REV.
B

AS3141

(R) STUD, STEPPED - 2.5 DIA ENGAGEMENT, PD SHANK, AMS5731
.3750-24 UNJF-3A X .3125-24 UNJF-3A

AS3141
SHEET 1 OF 2

FIGURE 1

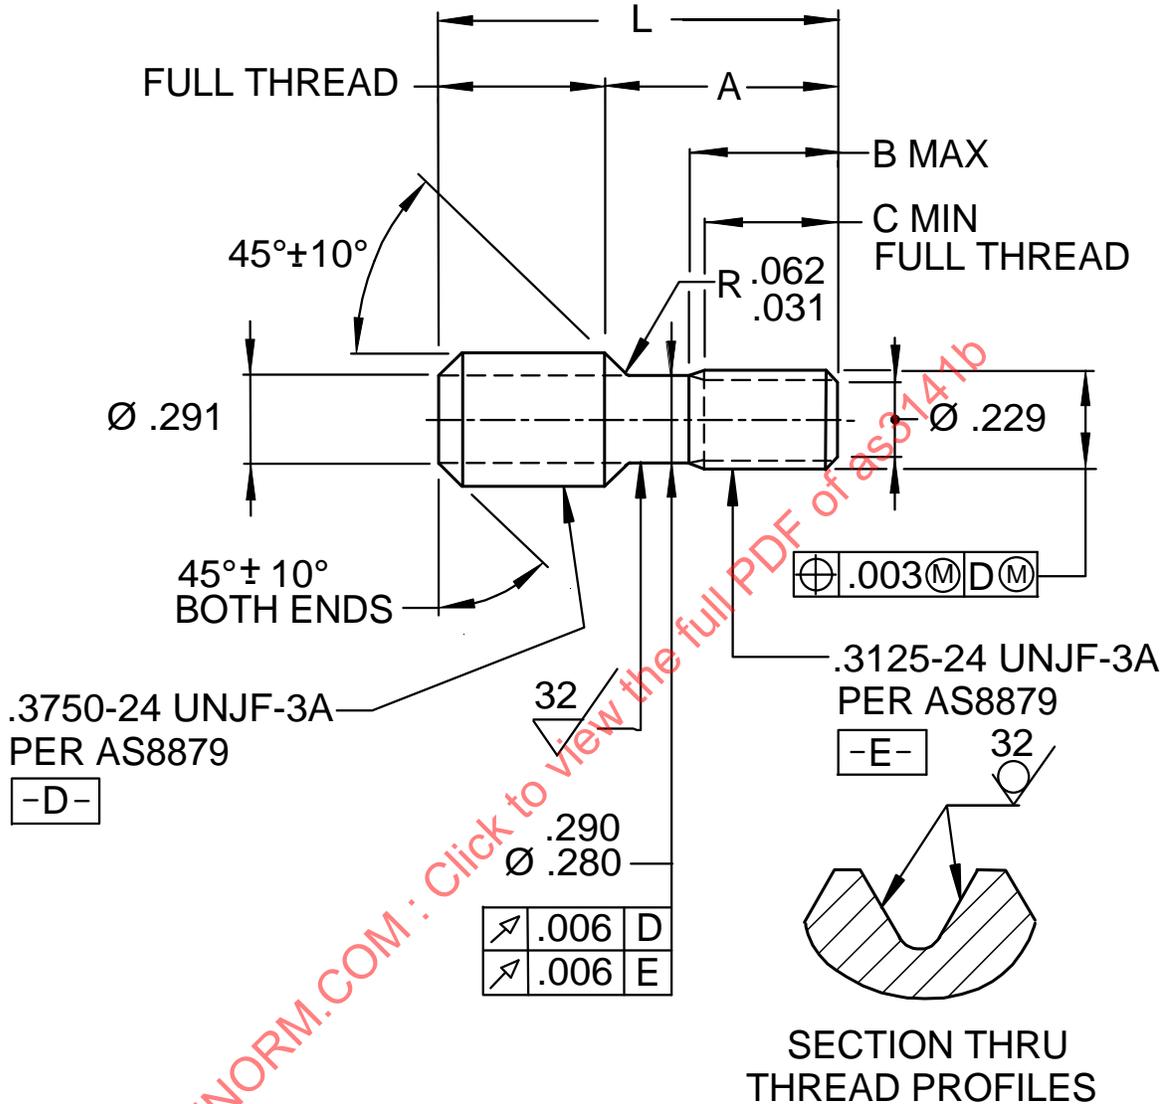
REVISE THREAD SPECIFICATION TO AS8879, UPDATE FPI REQUIREMENTS, REDRAW TABLE TO DELETE METRIC DUAL DIMENSIONING, REFERENCES UPDATED WHERE REQUIRED.
